ADDENDUM NO. 8

Reference: Holland Centennial Commons
Dixie State College – St. George, Utah
DFCM Project No. 06297640

ADDENDUM #8

PROJECT:	**Dixie State College of Utah** **Holland Centennial Commons**	**ARCHITECT'S PROJECT NO:**	09625
		No. Pages:	38 pages
OWNER:	Dixie State College	**DATE:**	January 6, 2011
ARCHITECT:	VCBO Architecture	**GENERAL CONTRACTOR:**	
SUBMITTAL DATE:	January 19, 2011	**SUBMITTAL TIME:**	12:00pm

Addendum #8
Sheet A324

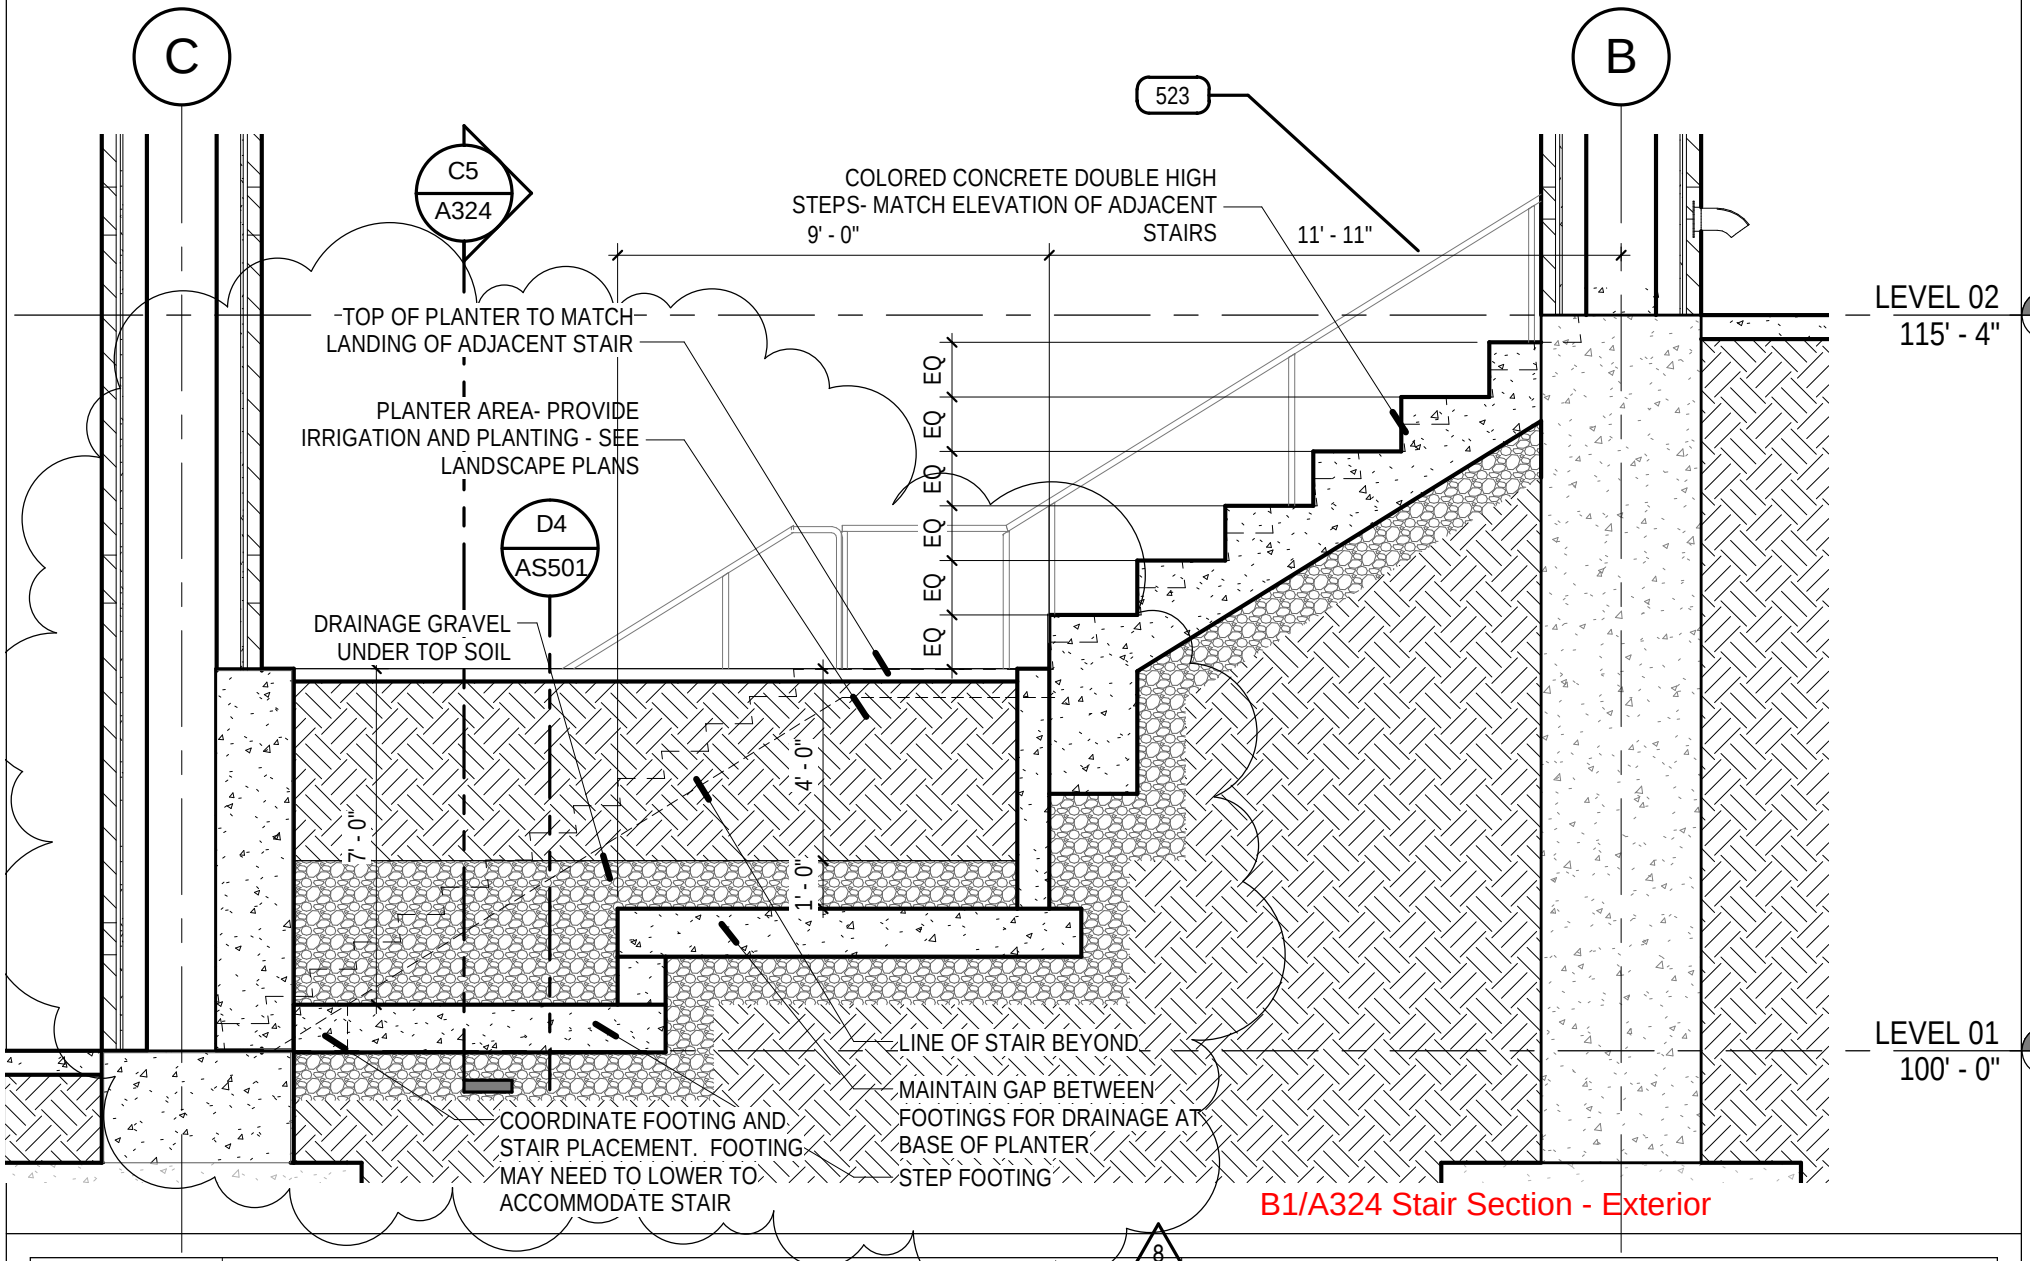
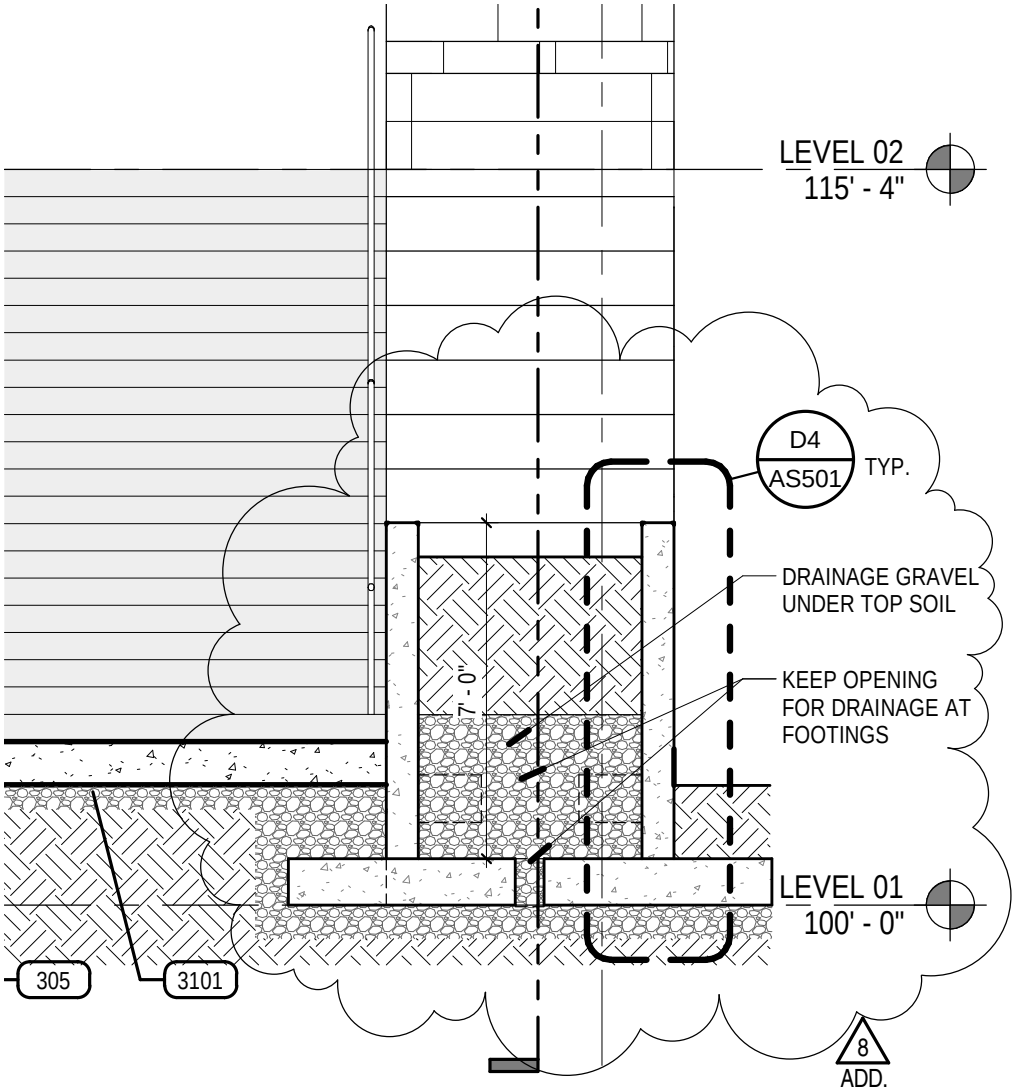
1. Section B1/A324 has been relabeled to be C1/A324. This section has been modified to show the footing for the planter box. The footing steps from the top of planter wall and is labeled to match the height of the adjacent stair landing. Drainage gravel has also been shown. A detail callout to refer to detail D4/AS501 has been added to this section. There is a note that coordination of the footing and the stair is required at the base of the stair where there is a conflict. See attached.
2. Section C5/A324 has been modified to show the footing for the planter box. The drainage gravel has also been shown. See attached.

SHEET TITLE: LEVEL 2 POWER PLAN

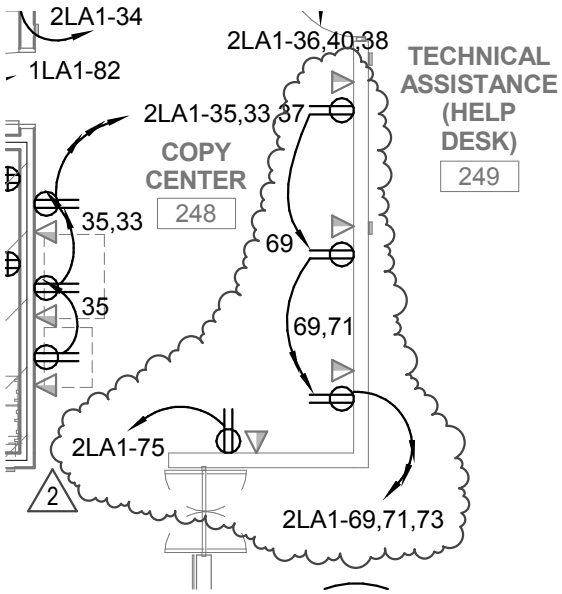
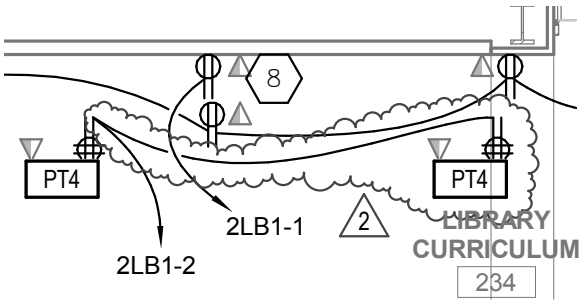
1. Add receptacles and voice/data outlets to Copy Center 248 as shown on attached revised drawing EP102-RV2-1.
2. Add second PT4 poke-thru device to Library Curriculum 234 as shown on attached revised drawing EP102-RV2-1.

SHEET TITLE: LEVEL 2 MEZZANINE POWER PLAN

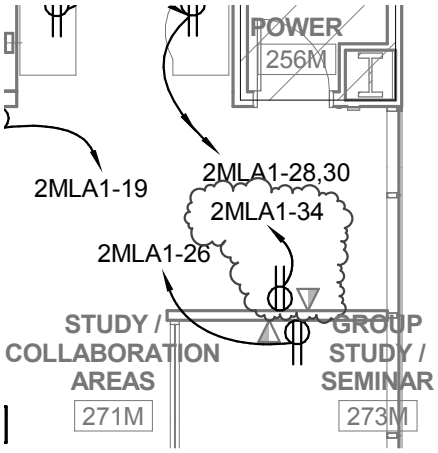
1. Add receptacle for copier near gridlines C.3 and 5.8 as shown on attached revised drawing EP102M-RV2-1.

SHEET TITLE: LEVEL 3 POWER PLAN

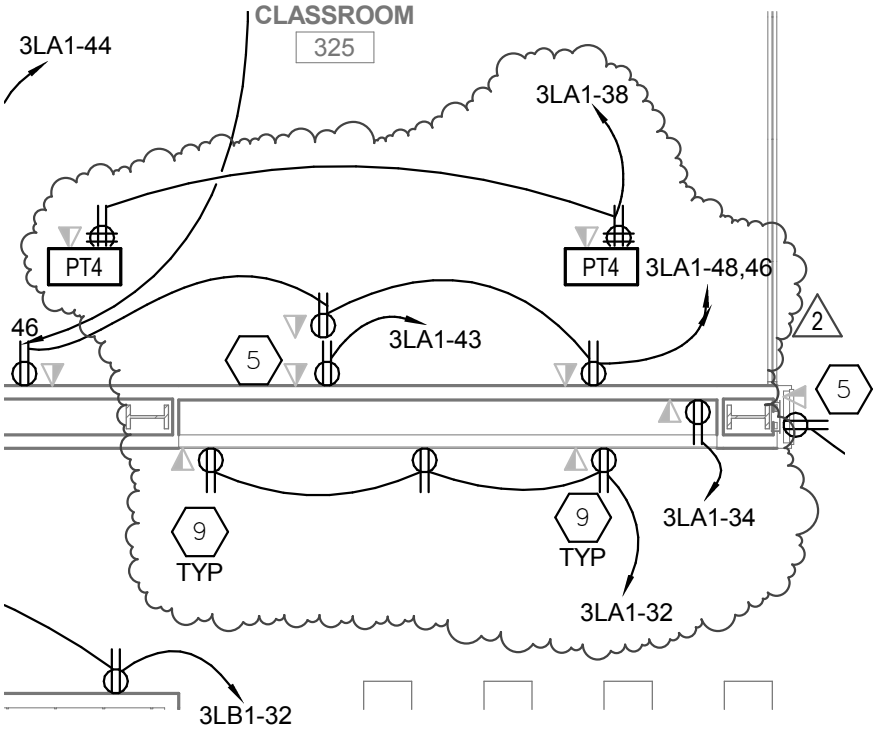
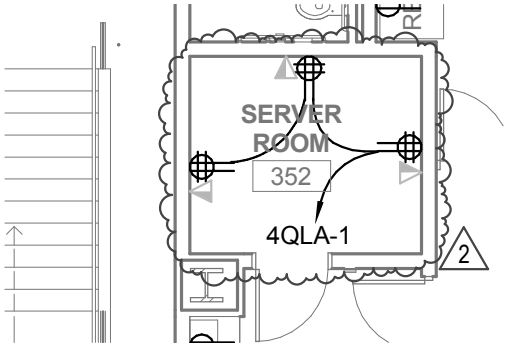
1. Delete plywood covering walls from Server Room 352.
2. Revise receptacle layout and add voice data outlets in Server Room 352 as shown on attached revised drawing EP103-RV2-1.
3. Add second PT4 poke-thru device to Classroom 325 as shown on attached revised drawing EP103-RV2-1.
4. Add receptacle and voice/data outlet for copier near gridlines B and 4. Relocate other receptacles as shown on attached revised drawing EP103-RV2-1.

EP105-RV2-1

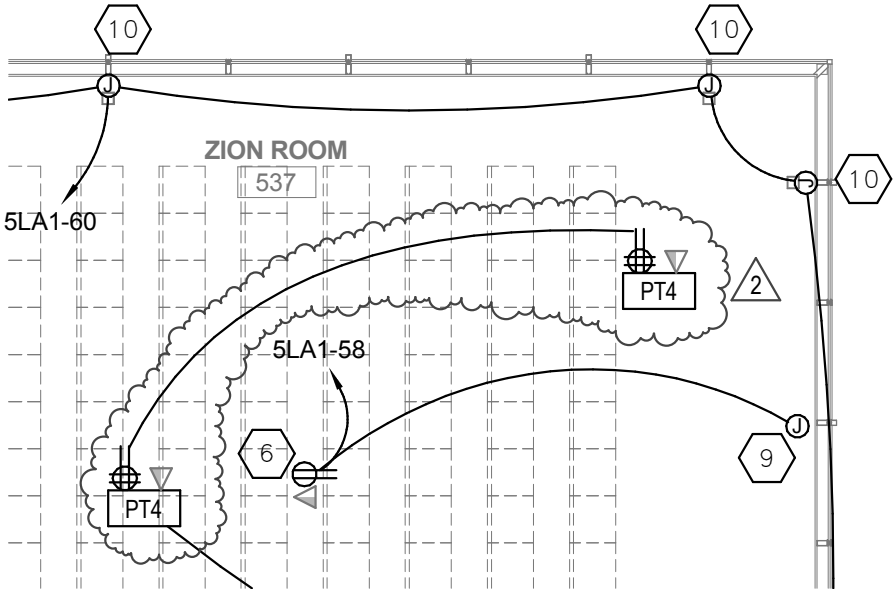
1. Add third PT4 poke-thru device to Zion Room 537 as shown on attached revised drawing EP105-RV2-1.

EP403-RV2-1

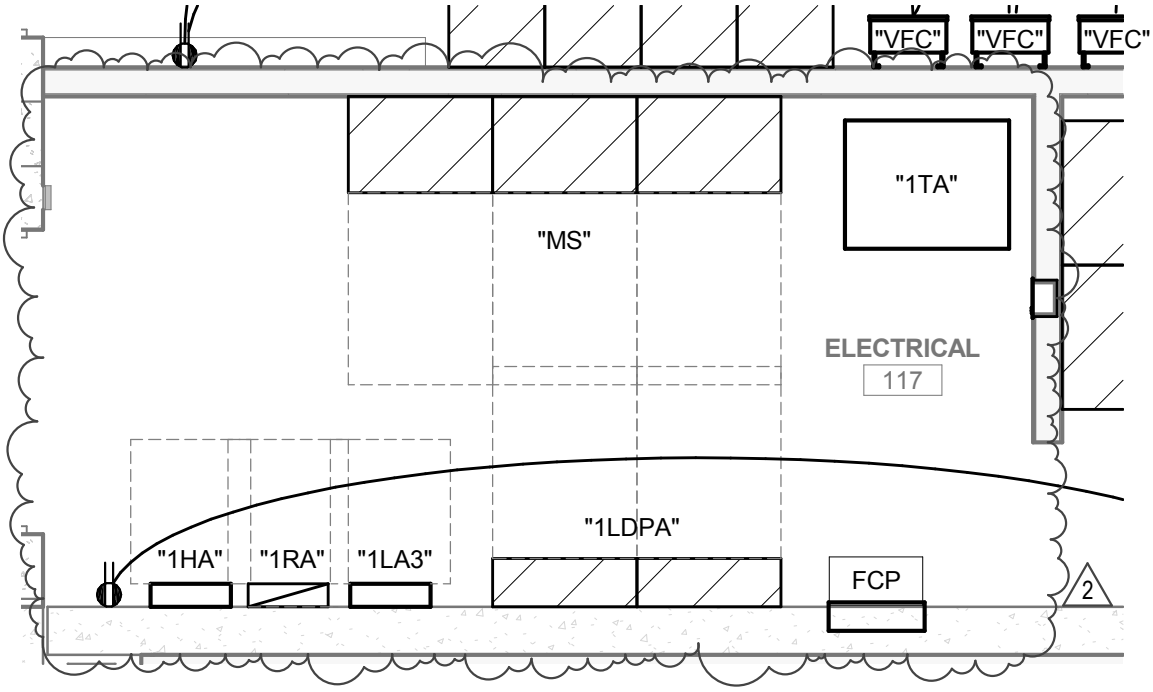
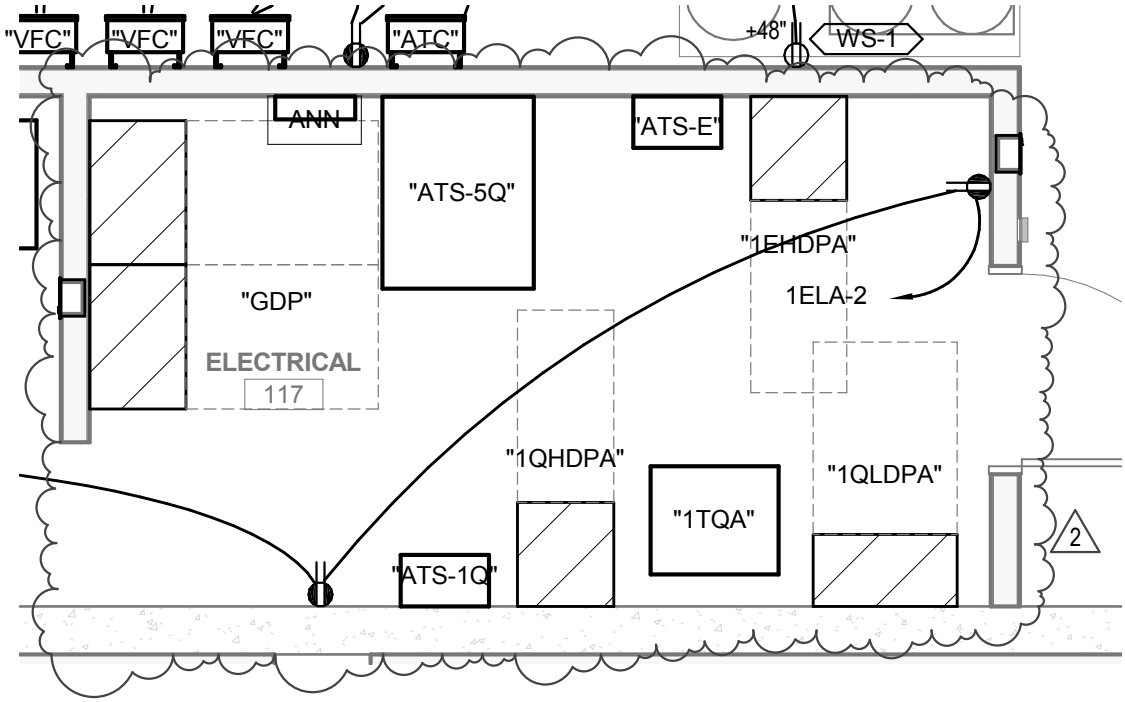
1. Delete lighting relay panel 1RA shown in electrical room 106. Relay panel 1RA is located in electrical room 117 as shown on sheet EP404.
2. Revise the layout of electrical room 113 as shown on the attached revised drawing EP403-RV2-1.

SHEET TITLE: ENLARGED POWER PLANS

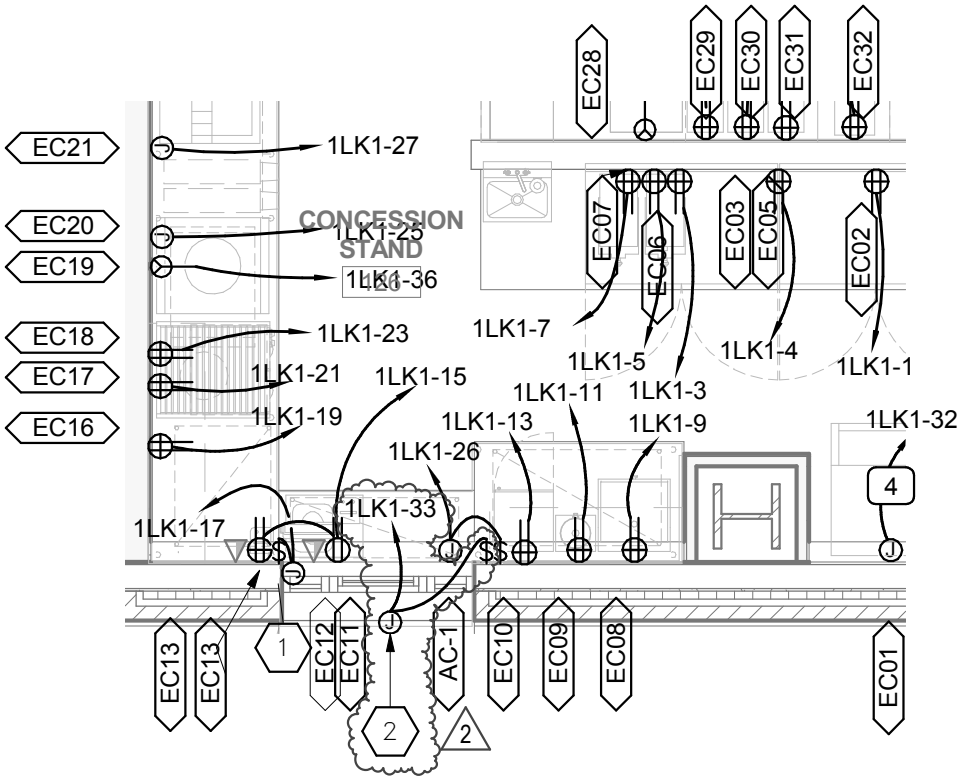
1. Add junction box, circuit and switch above serving window on of concession stand 126. Refer to attached revised drawing EP405-RV2-1.

A1 ELECTRICAL DEMOLITION PLAN – CENTRAL PLANT

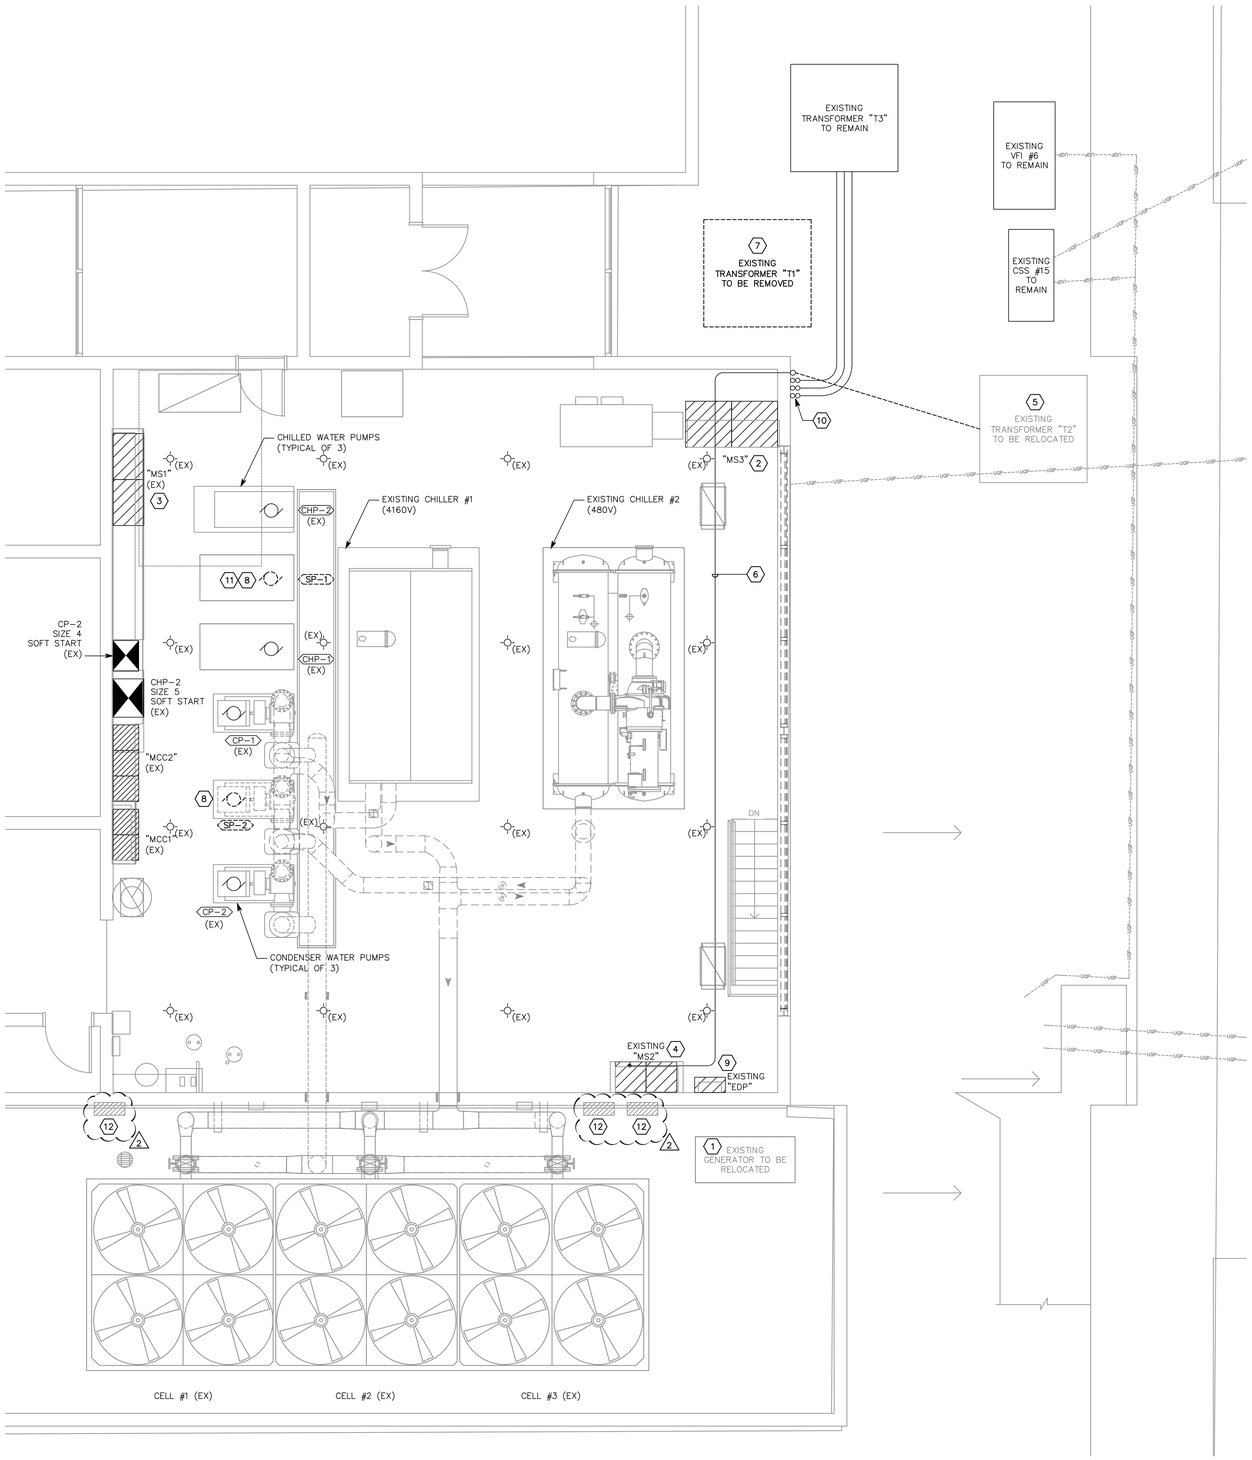
1. Add key note #12: "Remove existing control panels and install new control panels for existing cooling towers. Coordinate with mechanical installer." Refer to attached revised full size drawing EPD151.

C5 TRANSFORMER PAD DETAIL

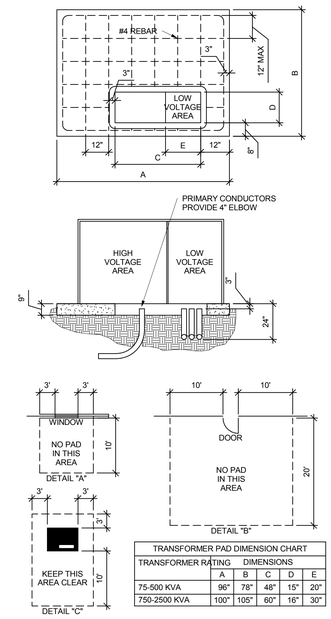
1. Add transformer pad detail. See attached revised full size sheet EP501.
